Seattle Design Commission

MINUTES OF THE MEETING

20 February 2003

Yesler Community Center site plan.

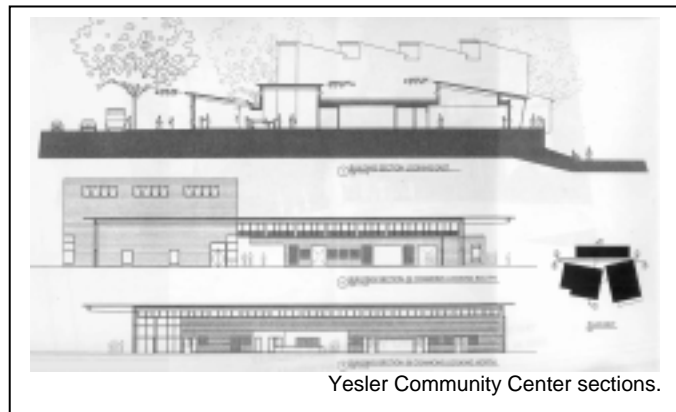
- urges the team to look again at the grading, belvedere and large retaining wall in back, recognizing that this has the potential to be cut in future budgets and consider other ways to integrate usable flat, open space with the grade change rather than having a single, large vertical wall;

- also encourages proponents to design the grading on the south in a manner that fits with the delightful terrace character of the building massing; and

- Would like to know if there is a balance in terms of cut and fill with the area under the gym and the belvedere because feels that could be a bonus. Since everything is on one level, believes that structural support would be necessary under the gym even if the parking was not underneath.
 - Proponents stated that they are using a PT slab, which will save them 1 foot and will allow them to reduce the number of columns in the parking lot so it will feel safer.
- Would like to know how high the belvedere is above the lower areas.
 - Proponents stated that it is 14 feet above. Ten feet of that is exposed wall and an existing

- Commends the team that the created form allows the Blue Ring to be expressed. Believes that retaining walls are expensive and a bank is cheaper and can see the gradual erosion of ideas that were compelling in the landscape. Suggests the team look at the back area with more sympathy to the open space and wonders if the terrace could step down more.

- Suggests that maybe rather than stepping down, the terrace could slope. Rather than having a wall, people could climb up and down the landscape itself.

- Feels that there is no compelling argument that the decks need to be that size or all at one level. The building form could step down with the landscape.

- Proponents stated that there are trade offs to terracing. Originally, the terrace was flanked by a ramp to the south that provided an accessible route to the south entry. Following discussions with Parks and the team accessibility consultant it was decided that an elevator would be preferable. The ramp was eliminated to offset the added cost of the elevator.

- Proponents stated that they did have a scheme with stepping down and a ramp, but DSHS requires open space adjacent to childcare and they need a spilling out space off the multipurpose room for weddings and other large gatherings. Does agree that it is a good idea to try and soften and break up the space and will look at the scheme again.
